**FINAL DESIGN REVIEW
DATA PACKAGE
BEAM TUBE MODULE
DESIGN & QUALIFICATION TEST
CONTRACT C146**

**CBI TECHNICAL SERVICES COMPANY
PLAINFIELD, ILLINOIS
APRIL 11, 1994**

CBI CONTRACT 930212

SUBJECT BEAM TUBE ERECTION SEQUENCE REQUIRED TO RESIST CONSTRUCTION EXPANSION JOINT LOADS ON FIXED SUPPORTS	OFFICE		REVISION:		REFERENCE NO.
	(CBI)				
	MADE MRS	CHK'D	MADE	CHK'D	SHT ___ OF ___
	DATE 4/22/94	DATE	DATE	DATE

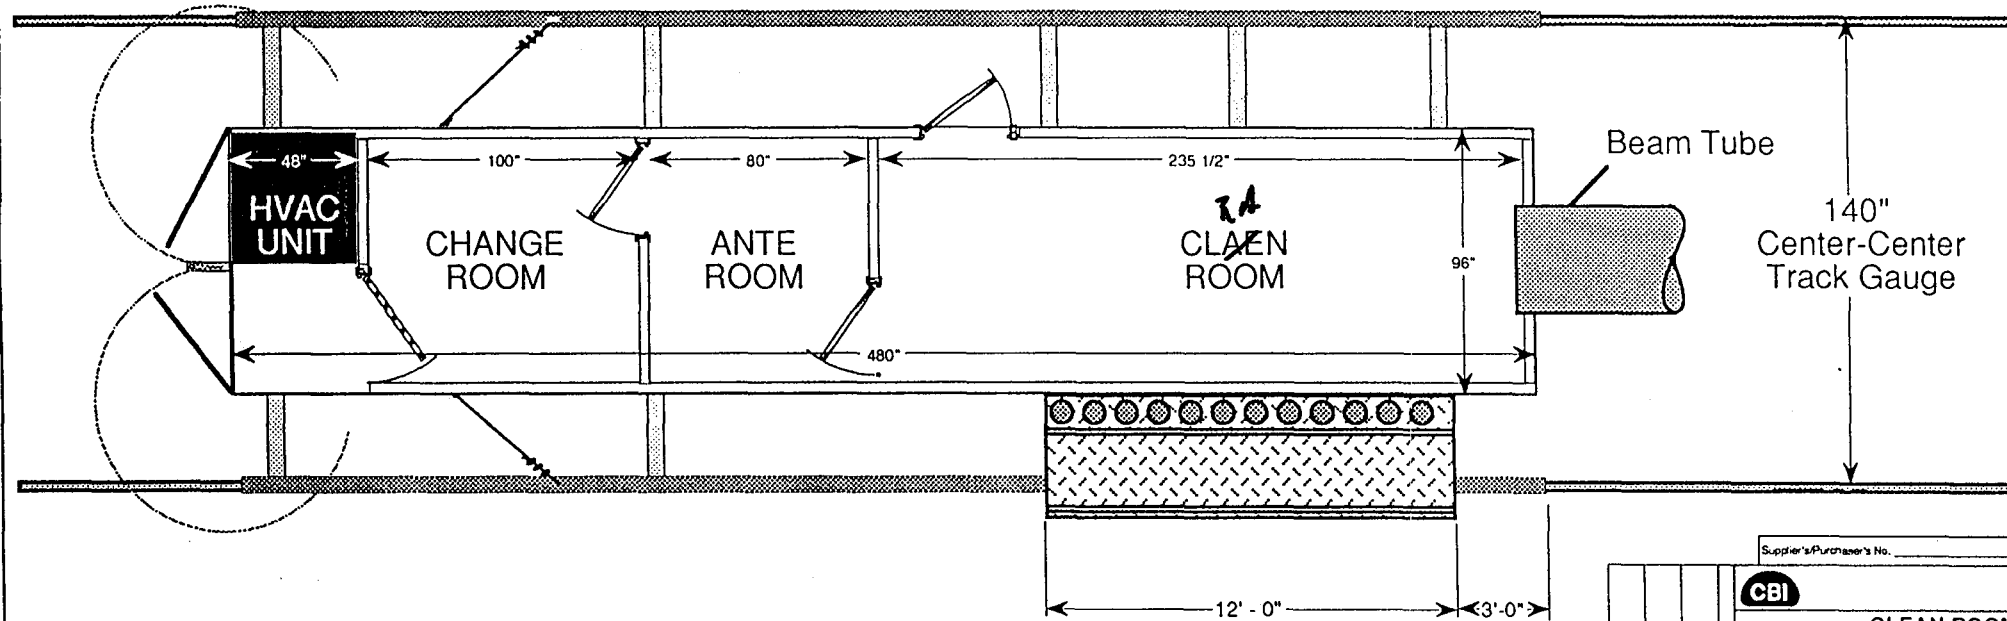
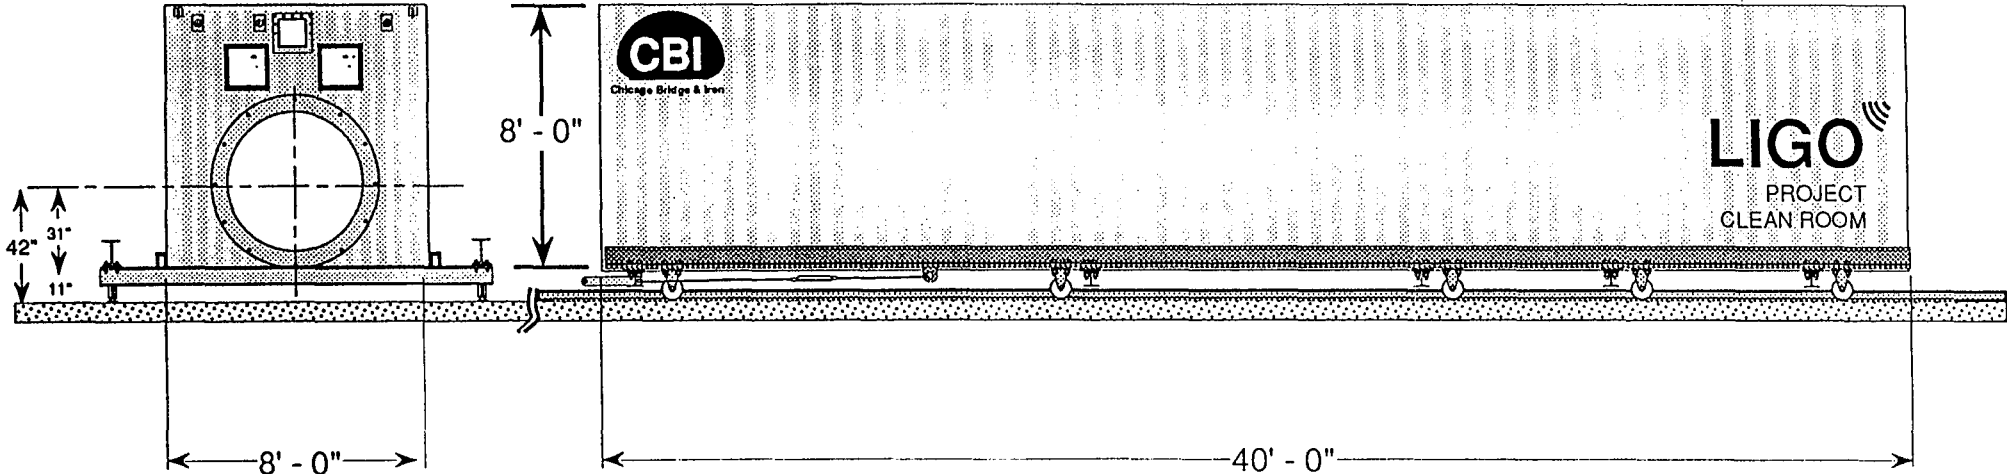
Align Check that the align procedure ~~is~~
place the supports before welding the circumferential weld
in the process to place the tubes in their supports
individually before circumferential welding

Do not conduct the rotation of the beam tube
once welded - this will increase the expansion
joint

SUBJECT THRUST RESTRAINT QUALIFICATION TEST LIGO	CBI OFFICE		REVISION:		REFERENCE NO.
	MADE MRS	CHK'D <i>DDG</i>	MADE	CHK'D	SHT ___ OF ___
	DATE 4/1/94	DATE 4/6/94	DATE	DATE	SK-QT1

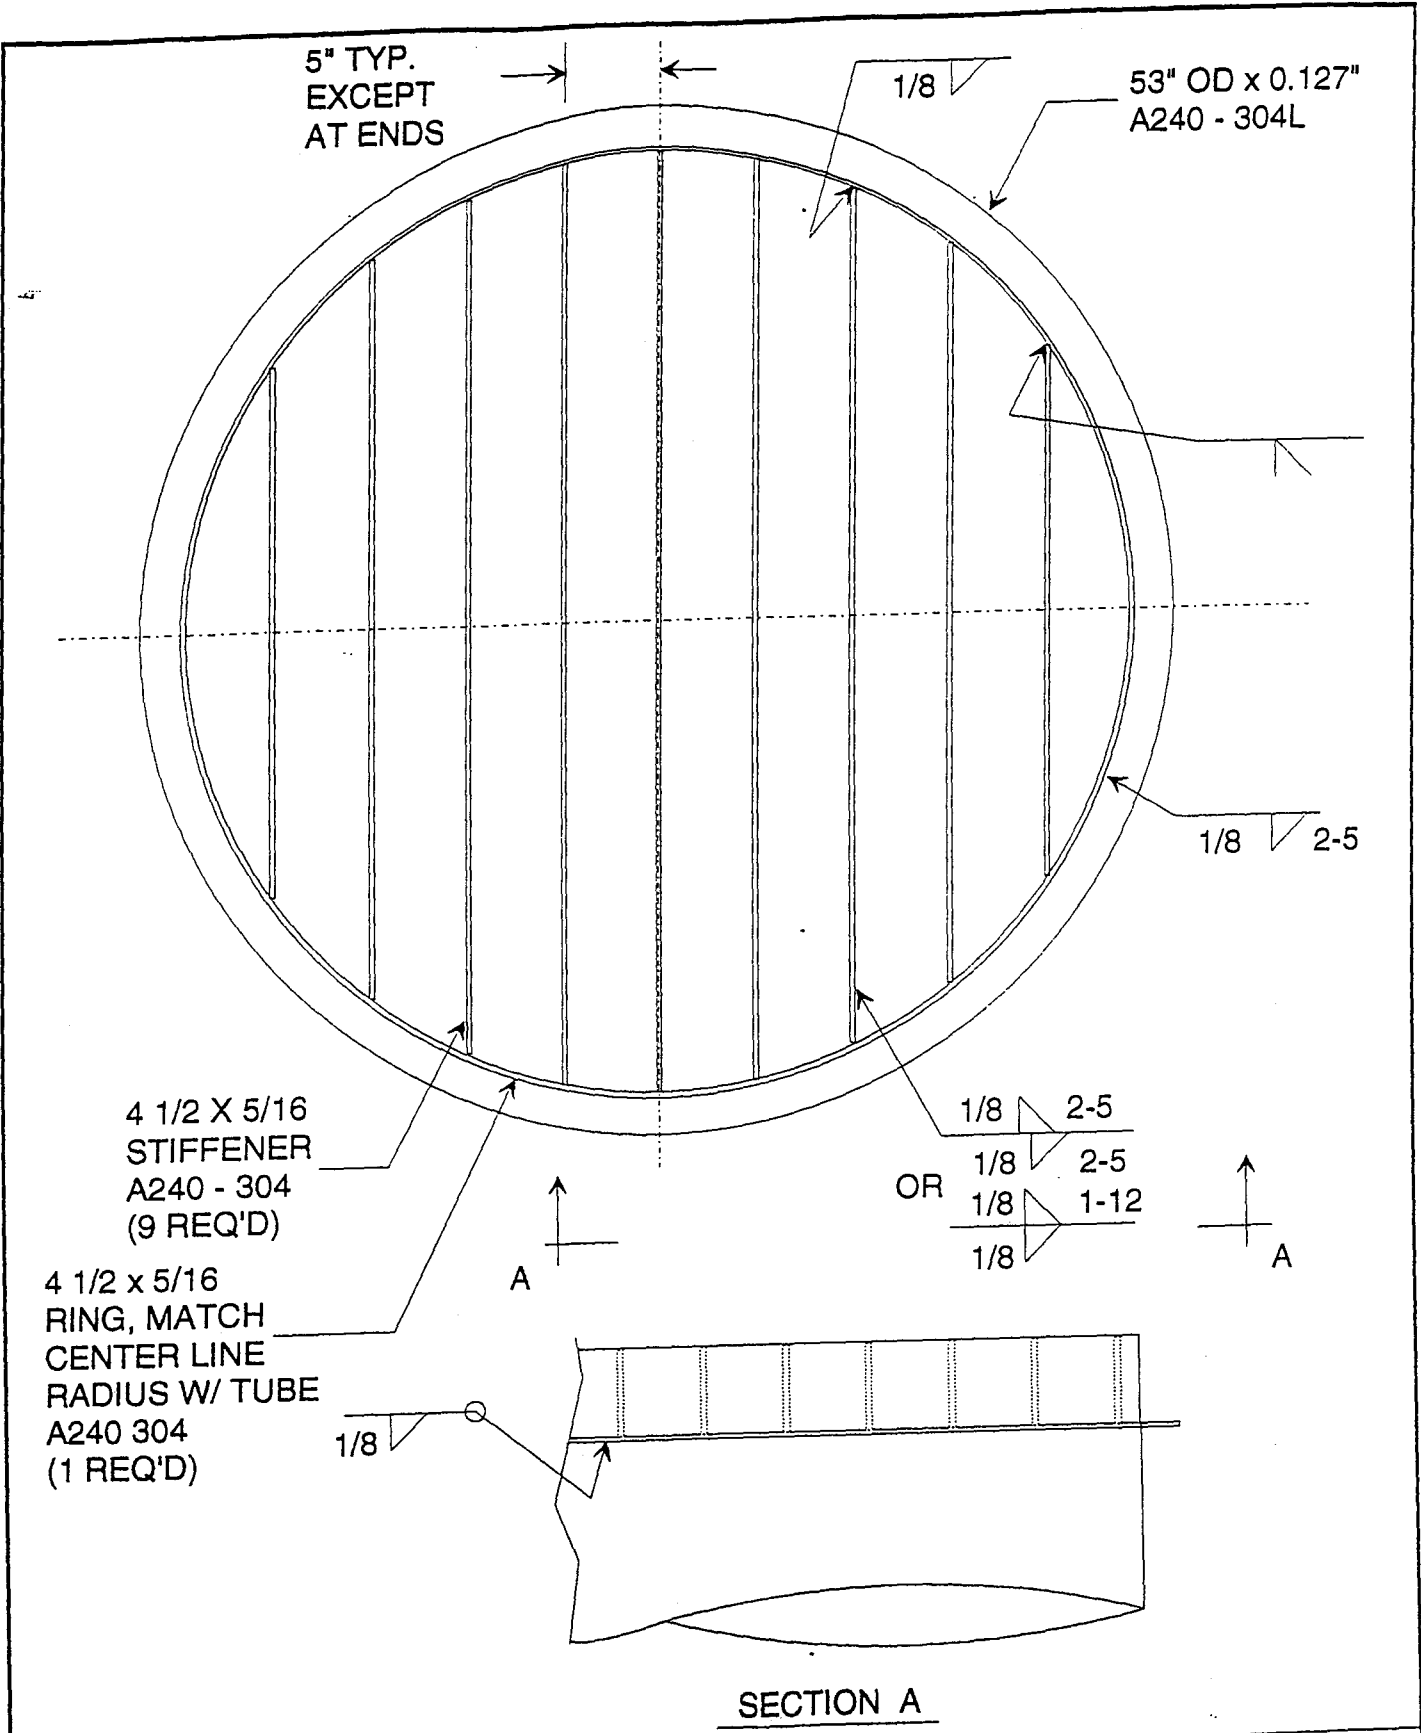
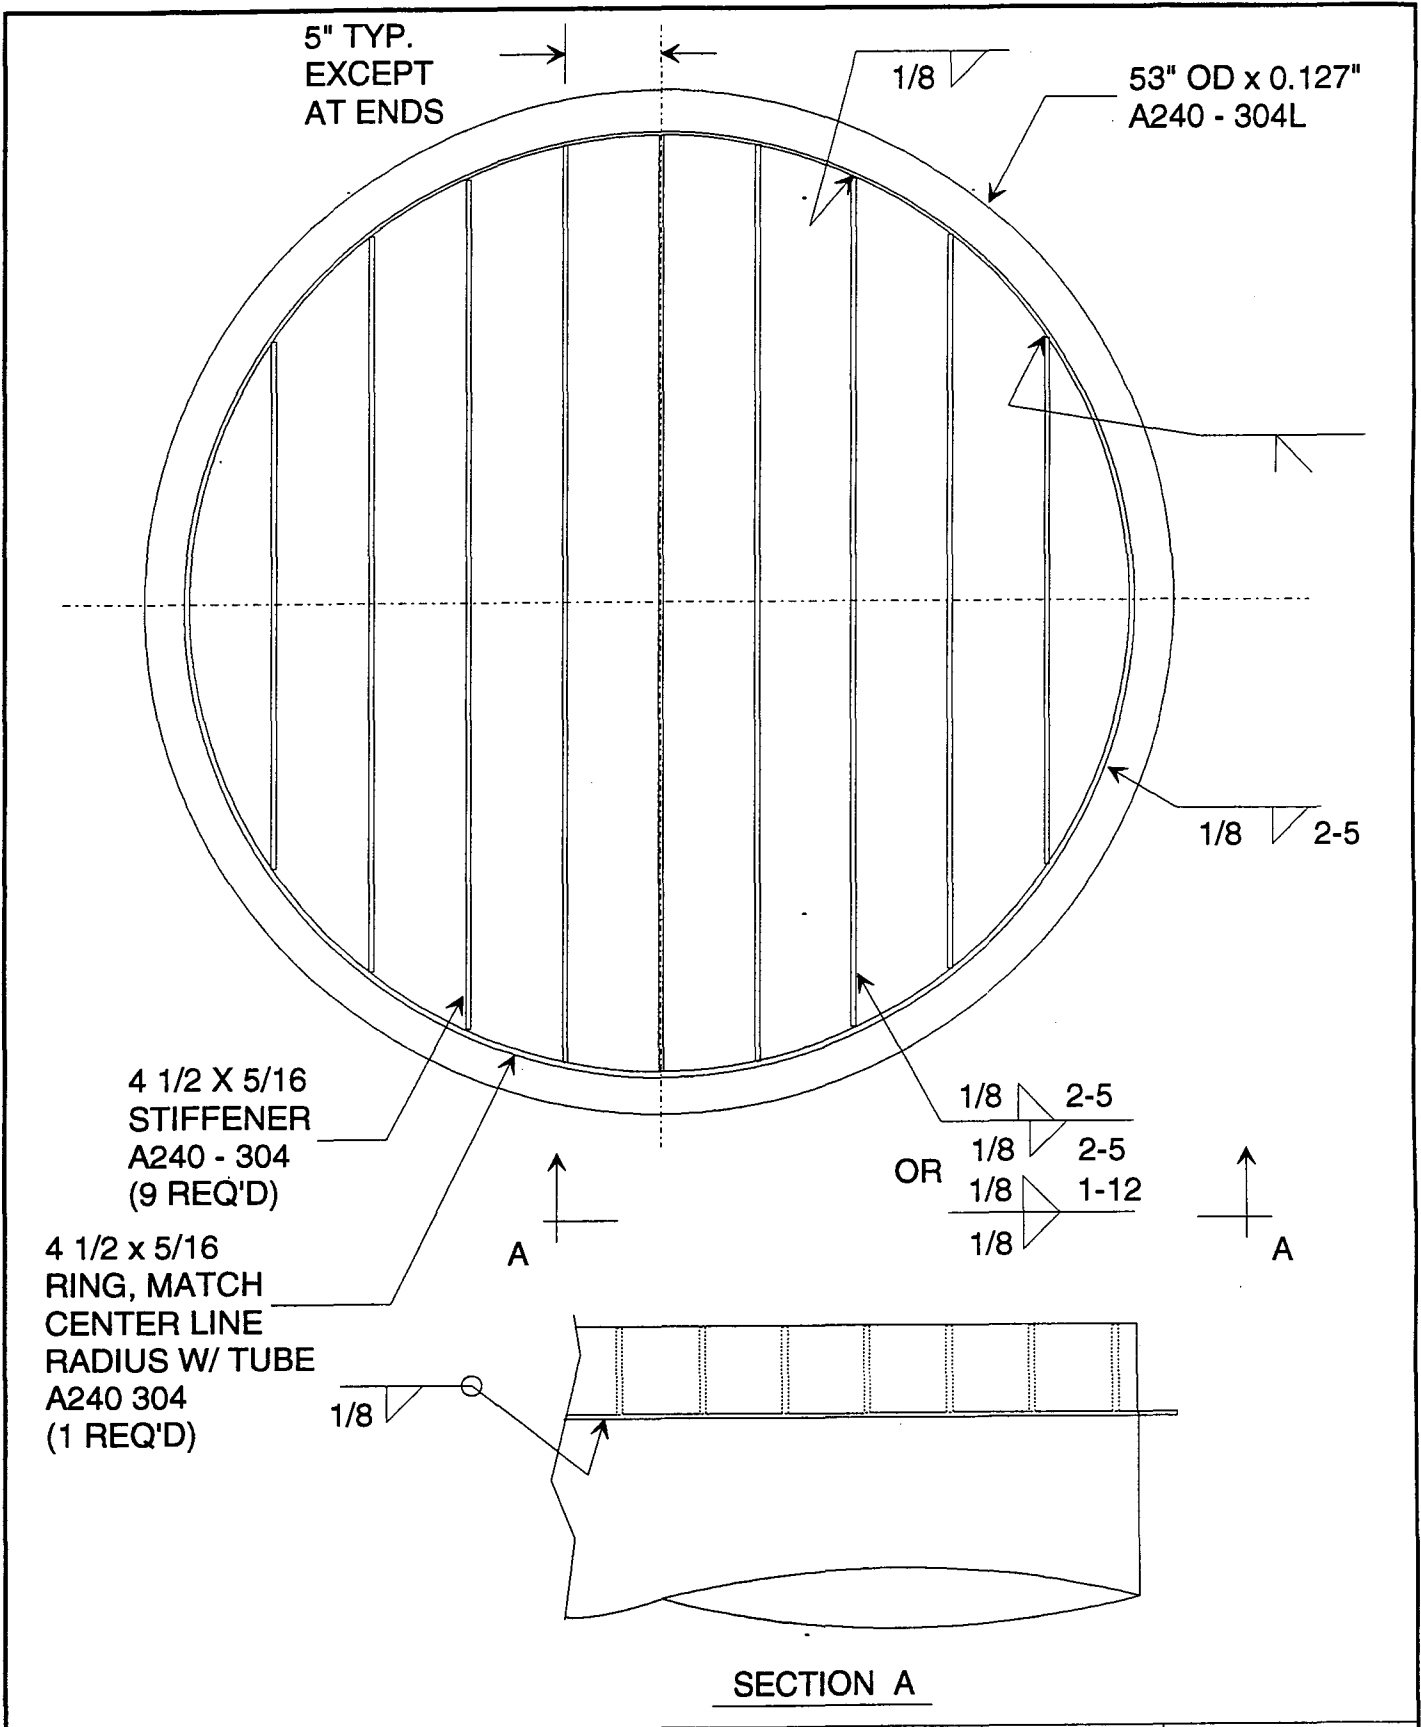
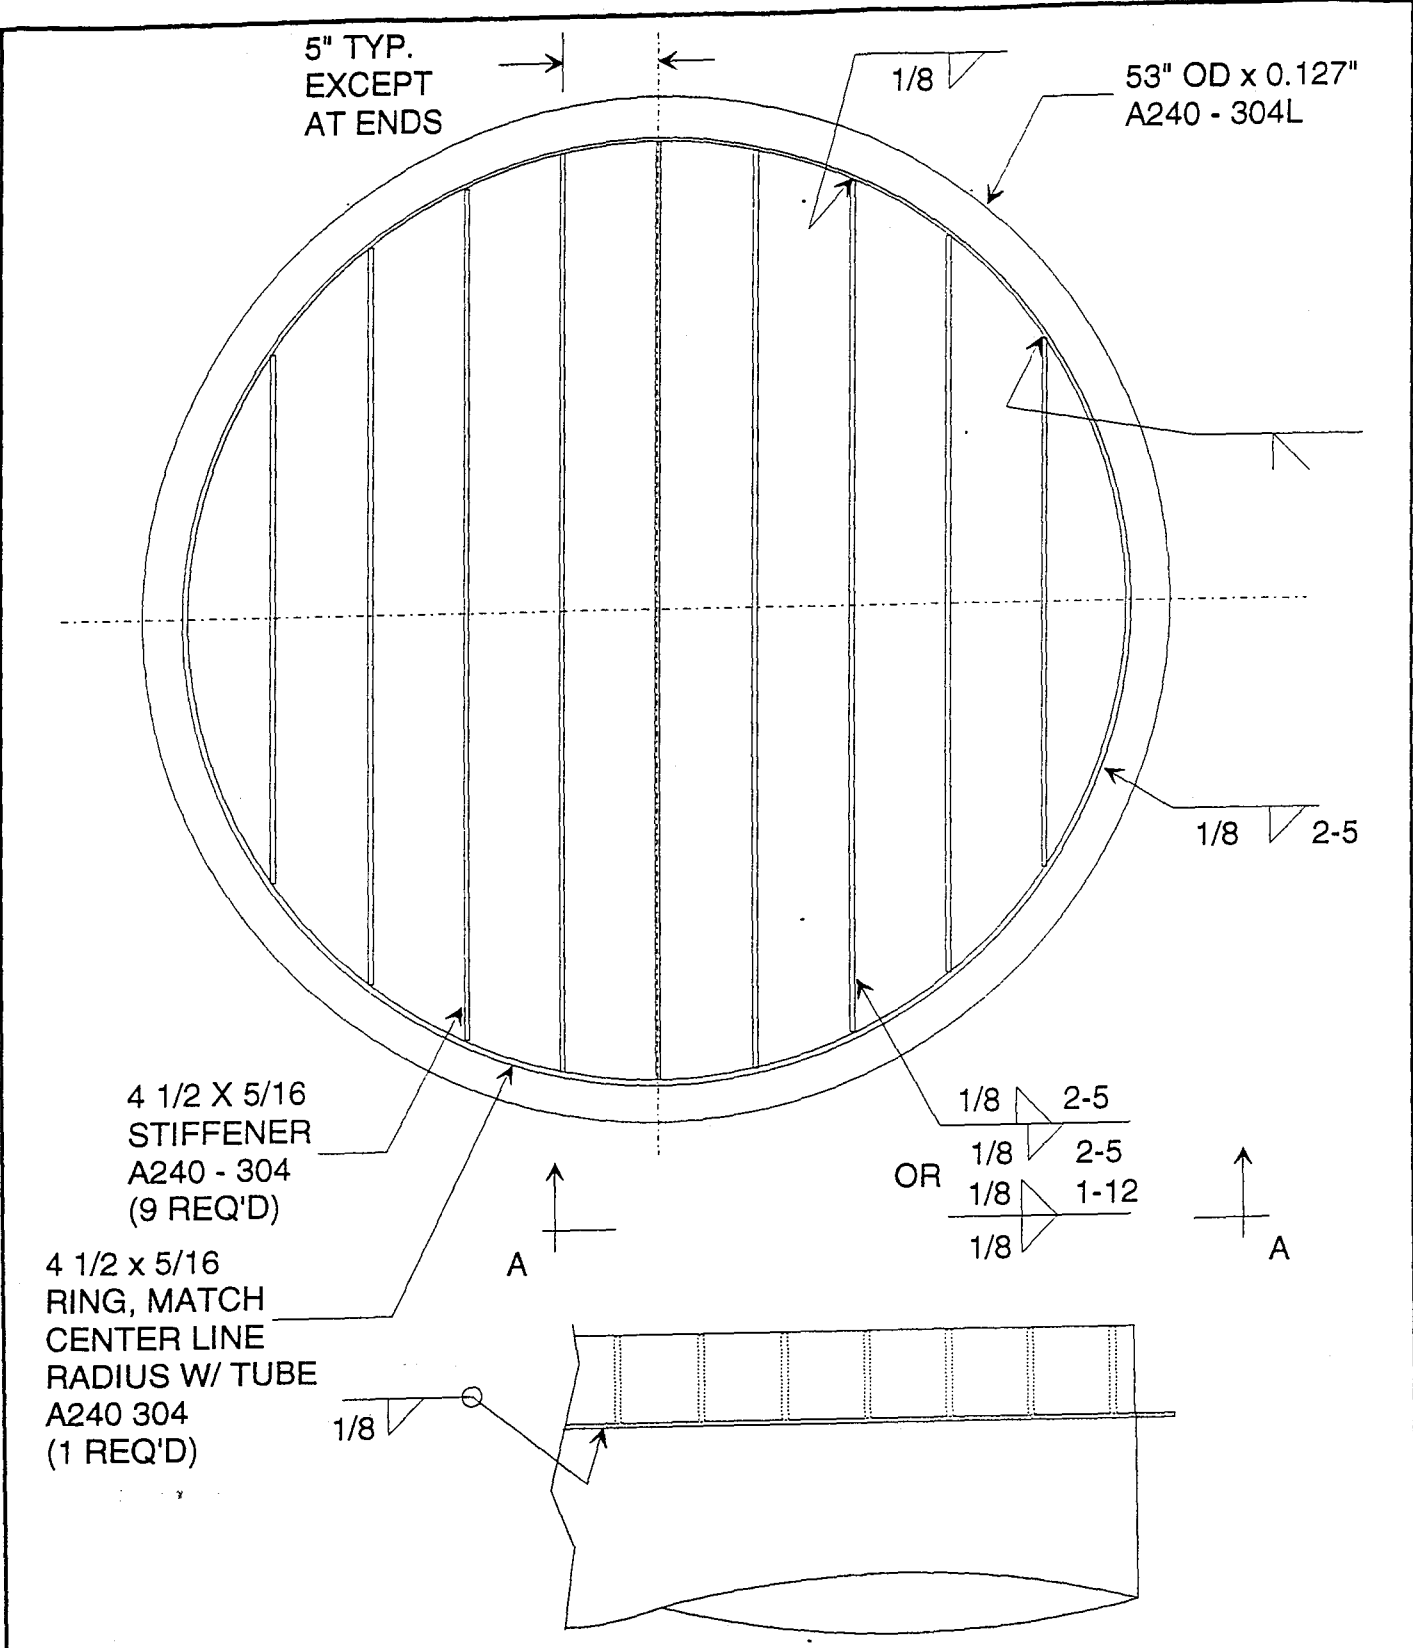
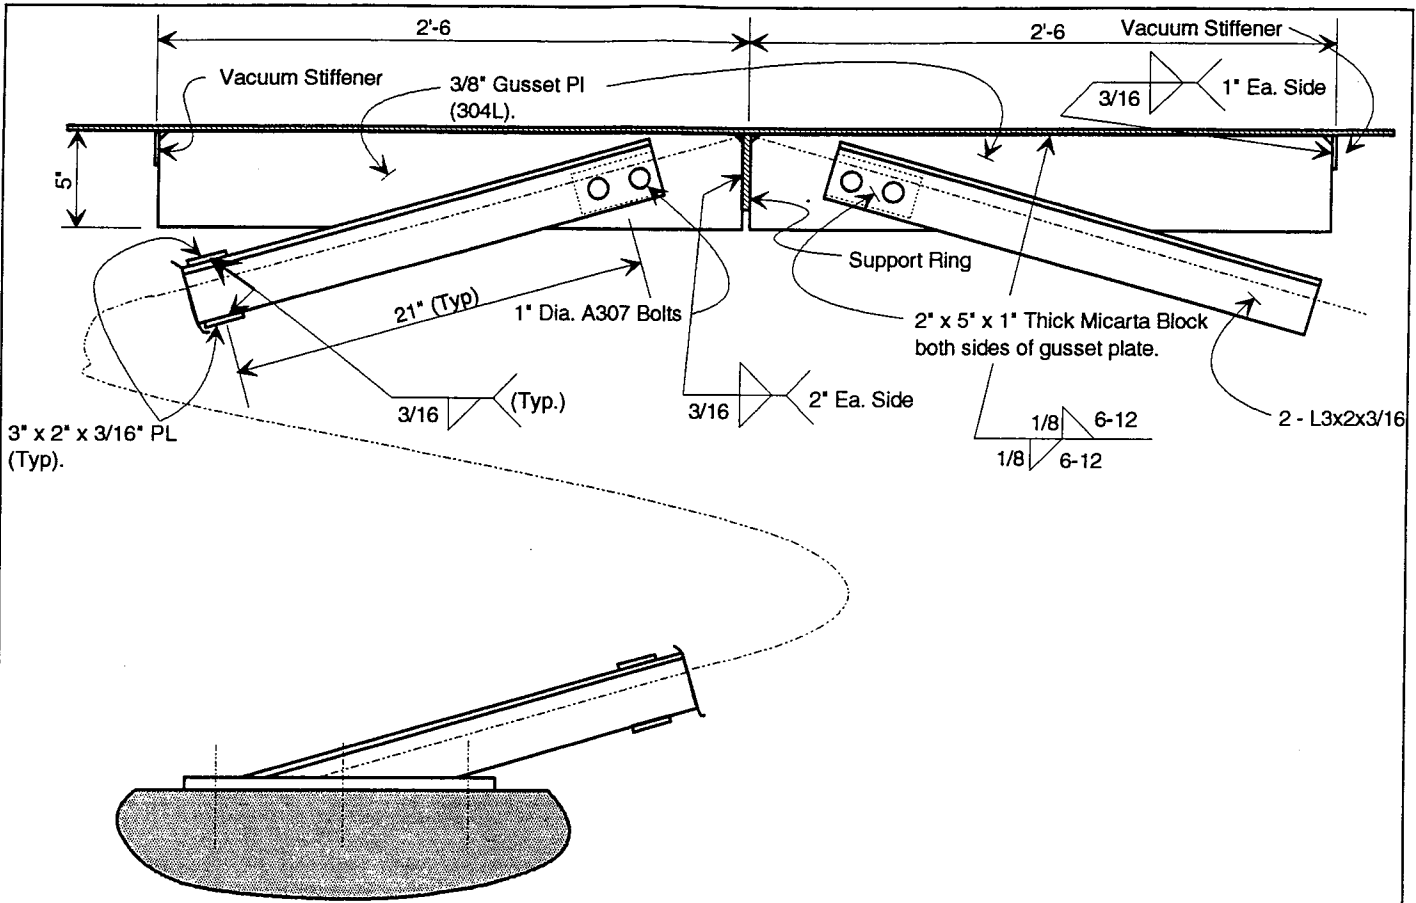
Figure SK-QT1 Thrust restraint on fixed supports. Has a thermal analysis been carried out for this support? What is the anticipated heat leak during bake?
